SUPPLEMENTAL DRAWING
 U.K. HOSPITAL EXPANSION

ALBERT B. CHANDLER MEDICAL CENTER UNIVERSITY OF KENTUCKY HOSPITAL EXPANSION & RENOVATION

First Floor Auxiliary Systems
 HOSPITAL EXPANSION & RENOVATION
 A.B. CHANDLER MEDICAL CENTER
 PROJECT NO. 304.1
 BID PACKAGE #2

M-32
 31 A-2 018728
 HOSPITAL ADDITL.

HVAC-FIRST FLOOR-REVISION ROOM# 1002A
 SCALE: 1/8" = 1'-0"

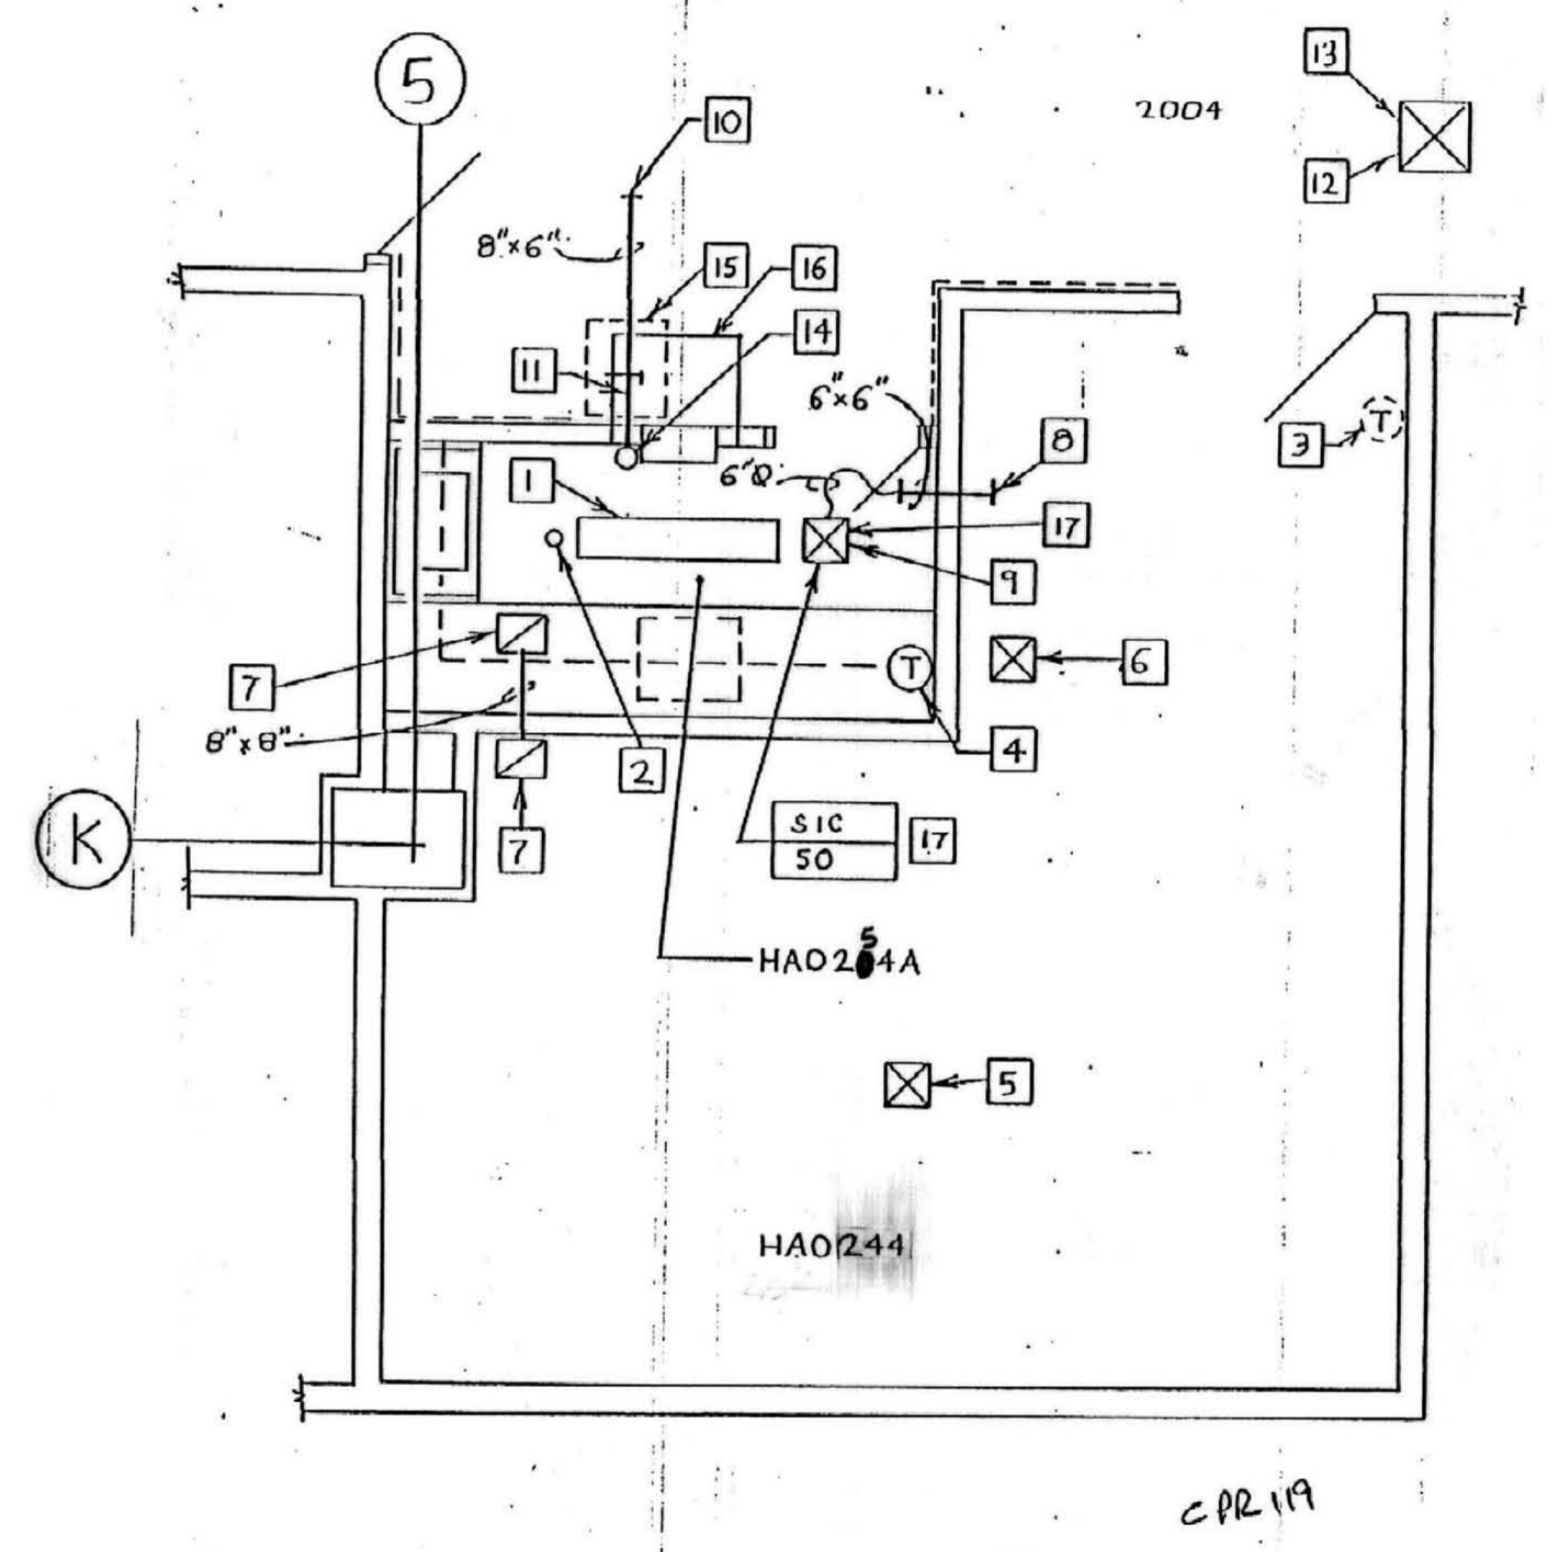
- CODED NOTES: NEW WORK - DRAWING 6 OF 7**
- NEW LOCATION OF EXISTING DIFFUSER.
 - NEW LOCATION OF EXISTING VOLUME DAMPER. SET DAMPER TO AIR VOLUME SHOWN ON DIFFUSER.
 - NEW DIFFUSER. SEE SCHEDULE ON DRAWING M-7 OF BID PACKAGE #2.
 - NEW RETURN GRILLE. SEE SCHEDULE ON DRAWING M-7 OF BID PACKAGE #2.
 - NEW SECTION OF RETURN AIR DUCT.
 - NEW 6" DIAMETER SUPPLY DUCT.
 - NEW FLEXIBLE DUCT.
 - NEW VOLUME DAMPER. SET DAMPER TO AIR VOLUME SHOWN ON AIR OUTLET.
 - CONNECT NEW DUCTWORK TO EXISTING DUCTWORK AT THIS POINT.
 - EXISTING DIFFUSER TO REMAIN. REBALANCE TO 300 CFM.
 - EXISTING STERILIZER EXHAUST AIR = 320
